7th September 2023

Section 92 Response Summary (in responding to Auckland Council’s S92 letter dated 13th July):

Figure 2 - Demonstration of the location of existing and proposed shooting bay 5 (more details see drawing RC113, RC200 of Appendix C - Infrastructure Report & Plans (Rev B))

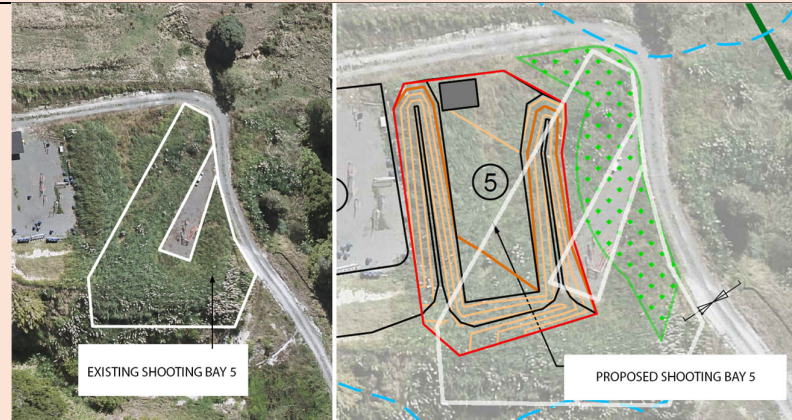
The proposed earthworks for shooting bay 5 appear to be within an area which could potentially meet the definition of a natural inland wetland under the NESFW. Accordingly, please provide wetland delineation results for the area, including soil

<p>plots, as this will provide a strong support tool for wetland extent alongside vegetation. In addition, please supply all wetland delineation data sheet forms for all wetland plots along the survey transects undertaken, as shown within the submitted Ecology Report.</p>	<p>The applicant has provided an Ecological assessment with detailed assessment of the site, concluding that area of existing bay 5 is not a natural inland wetland. The applicant relies on specialist's assessment. Please refer to applicant's Ecologist assessment in attached Appendix R – Ecology s92 Response.</p>
5	<p>Please review and further investigate whether the area that has already been excavated (and is proposed to be re-vegetated) can be maintained and used as a shooting bay, noting that this would potentially avoid the need for earthworks to allow for the creation of proposed shooting bay 5. This is particularly so should the requested information for question 4 determine that the area currently proposed for shooting bay 5 is a natural wetland. If it is not possible to reuse this area, please provide an explanation as to why not.</p>	<p>Section 5.2 – Description of the Proposal has demonstrated that existing bay 5 will be abandoned and replaced with the new shooting bay 5. The area of existing bay 5 is overgrown by exotic grass and cannot be used as a shooting bay (See figure 1 extracted from the AEE as per below).</p> <p>Additionally, the newly proposed shooting bay 5 will require earthworks to remove a significant section of existing bay 5's 3.5m high berm to establish a new berm with similar height (see Figure 2 below for more details). This earthwork activity will overlap, demolish and replace the existing structure of existing bay 5 and therefore will not allow any potentials to reuse this area as a shooting bay.</p>

As recorded during the ecological specialists site visits, the area around existing bay 5 was exclusively dominated by exotic dryland weeds such as pampas and gorse and does not possess any indication of wetland type vegetation.
